Sir Bernard Jenkin MP: Response to Norwich to Tilbury Consultation. July 15th 2024.

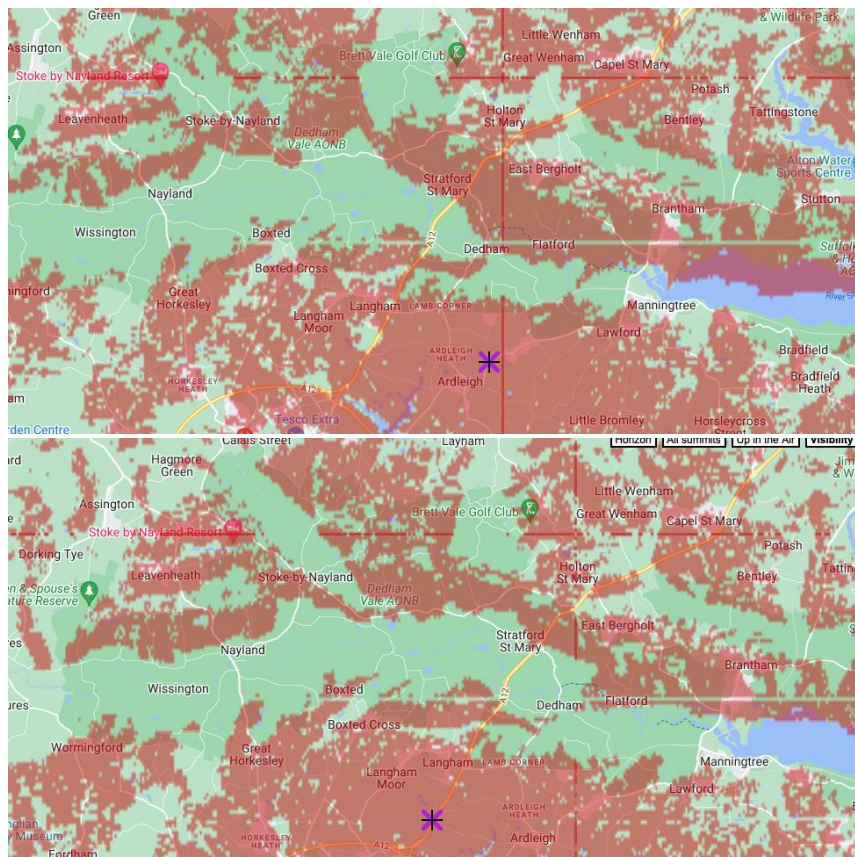
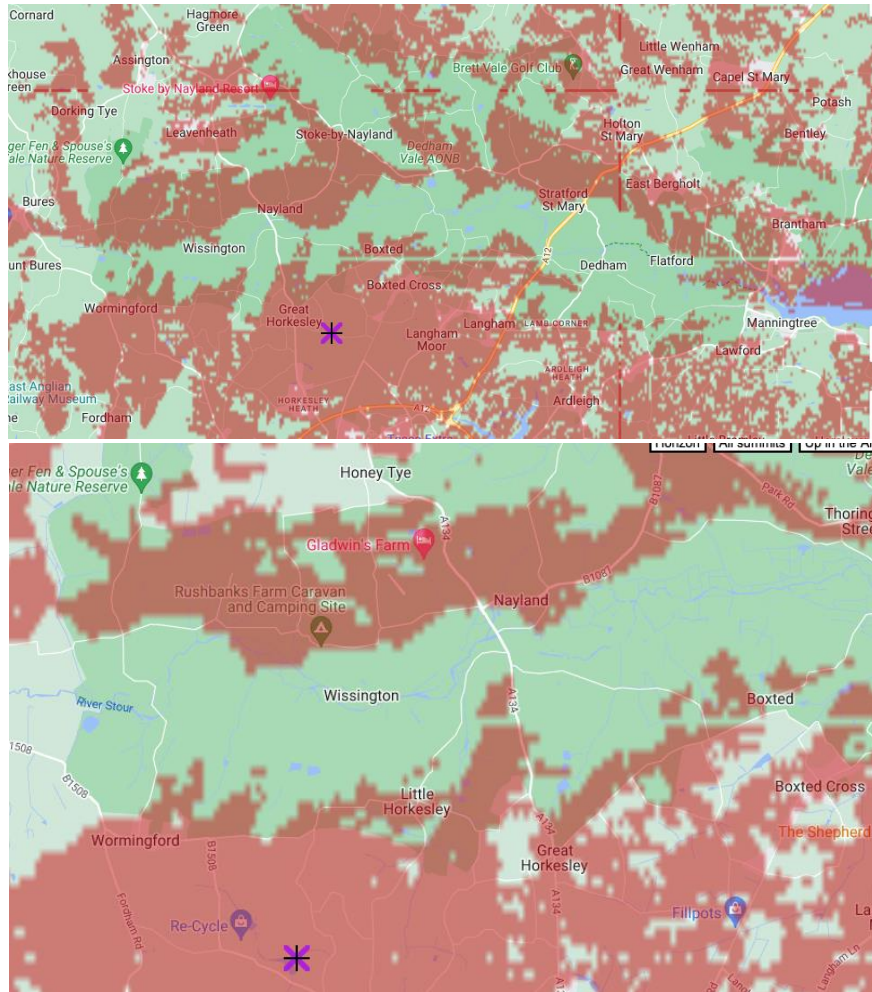
2.3.12 Figure 13.8.1 illustrates that, in the determination of National Grid, “some” pylons will be visible across a large proportion of the Dedham Vale, there are many locations within it from which between 11 and 30 pylons will be visible, and some sites at which between 50 and 60 pylons will be visible.

2.3.13 Figure 13.8.2 illustrates that, in the determination of National Grid, the full structure of pylons will be visible across large portions of the Dedham Vale. These facts taken together suggest that damage will be very significant.

2.3.14 The methodology employed in the construction of these figures is set out at 13.5.4 of the document “Preliminary Environmental Information Report – Volume I – Main Text”, which states: ‘The emphasis of this preliminary assessment is based on landscape and visual receptors within 3km of the operational overground elements of the Project and 1km of the operational underground cable route where it is considered that significant landscape and visual effects are most likely to occur’ and at 13.5.5 which states that ‘More distant viewpoints up to 5km from the Project are considered where there is the potential for significant visual effects to arise beyond the 3km study area, for example where there are particularly sensitive visual receptors and where topography allows more far-reaching views’

- 2.3.15 It is inarguable that a protected National Landscape is a ‘particularly sensitive visual receptor’, it is also inarguable that the pylons and sealing end compounds proposed to the south of the Dedham Vale follow the ridge and lie above the valley in positions from which they are likely to be widely visible. Whilst it is impossible to know which segments of the diagrams include data at 5km as opposed to 3km, the inclusion of some impact at 5km within both figures confirms National Grid’s assessment that the impact within the Dedham Vale arising from infrastructure outside of it along the southern boundary is ‘significant’
